Huntington Planning Commission Monday, April 1st, 2024 – 5:30pm

PC 24-03

Issue: Plan review of a proposal to redevelop 4514 Waverly Road on a property that is approximately 1.03 acres into a commercial retail establishment (Dollar General Market). The property is located at the northwest corner of the intersection of Waverly Road and Burlington Road in the Westmoreland neighborhood and is zoned C-2 Highway Commercial District.

Staff Report: Public Hearing for Preliminary Site Plan Review.

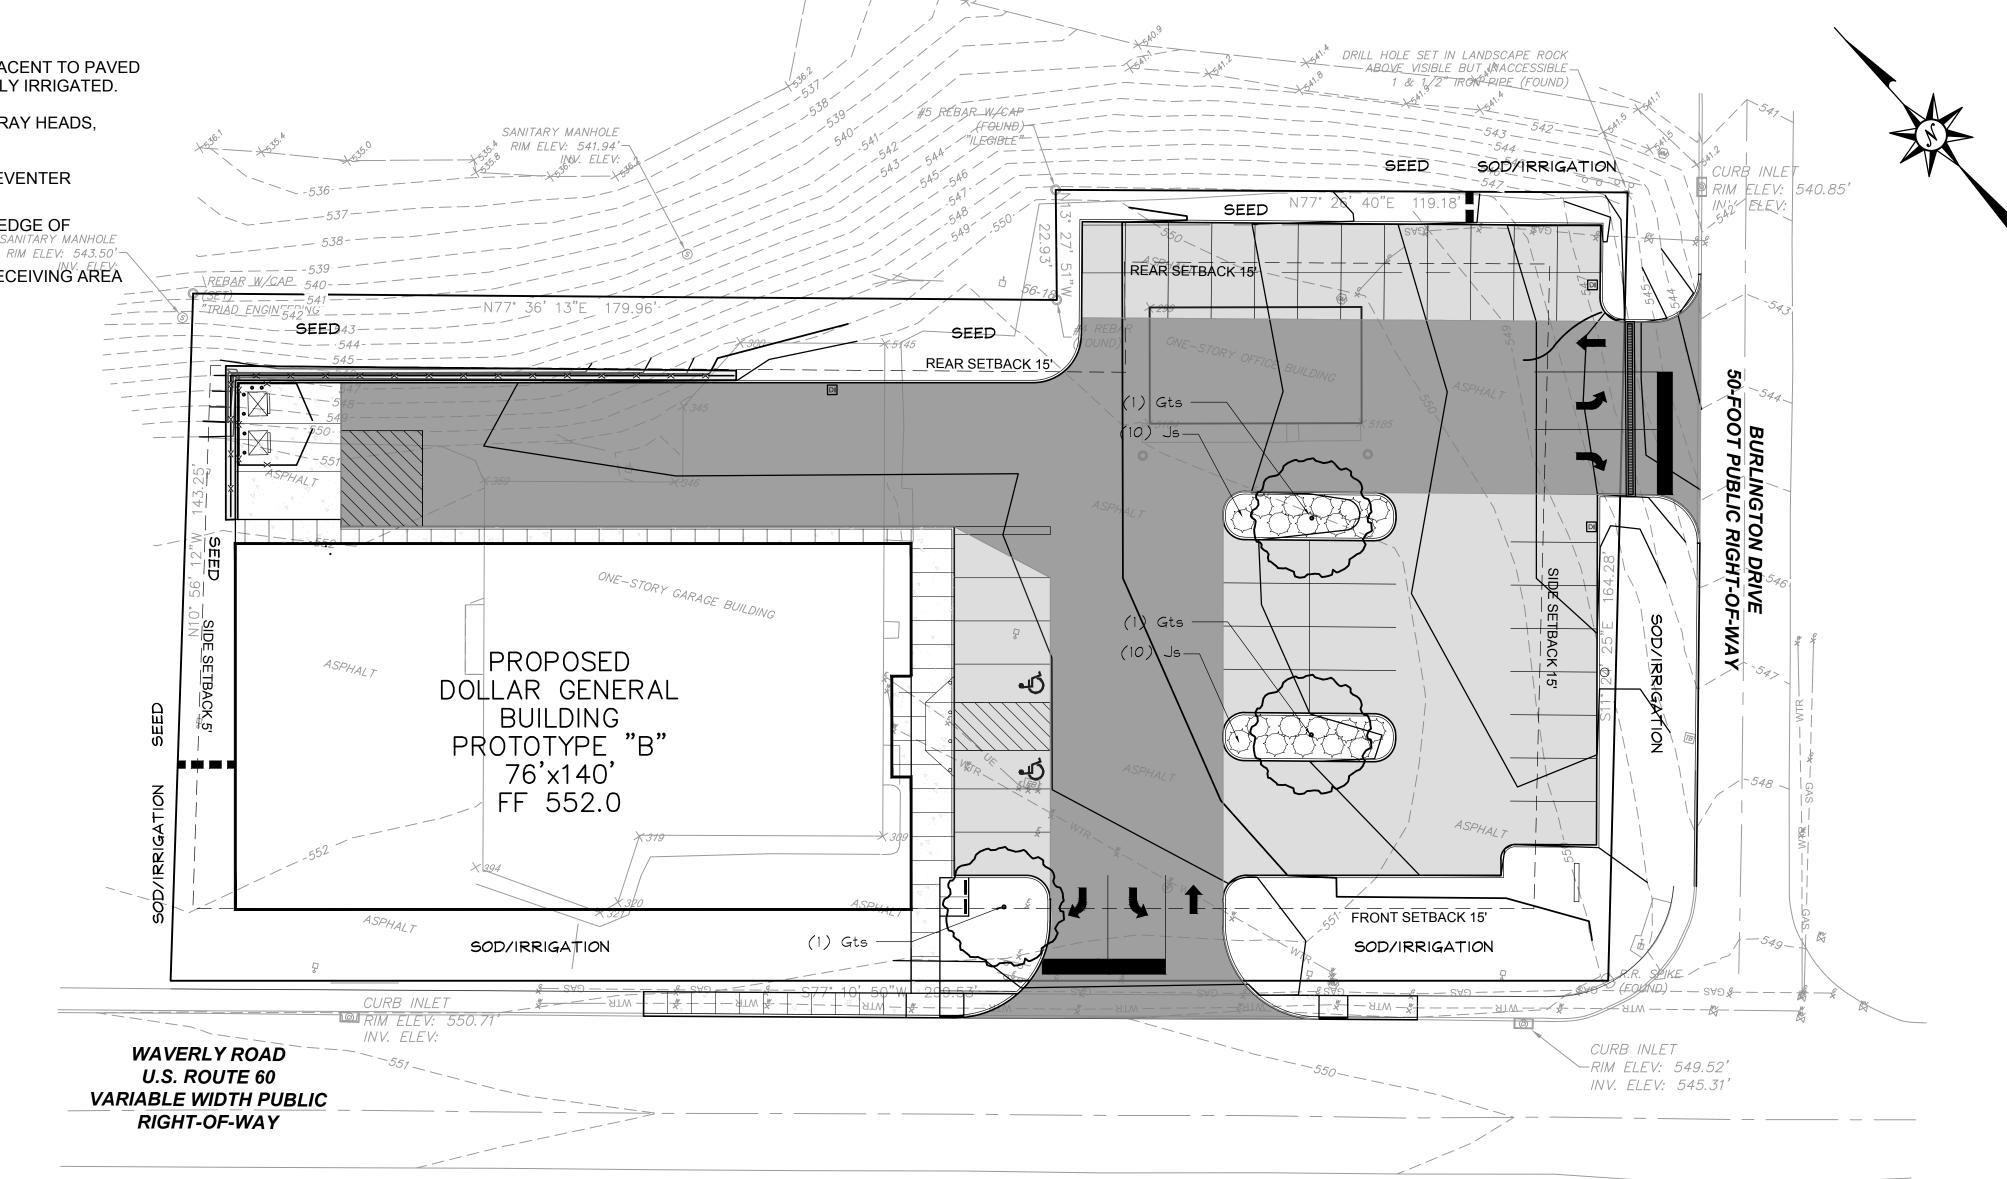
Five-percent landscaping is required by the ordinance but is not reflected in the site plan presented. Staff recommends that the Commission require landscaping be included, possibly to buffer the parking on Waverly.

STAFF RECOMMENDATION: Approve with the condition that 5-percent landscaping be added.
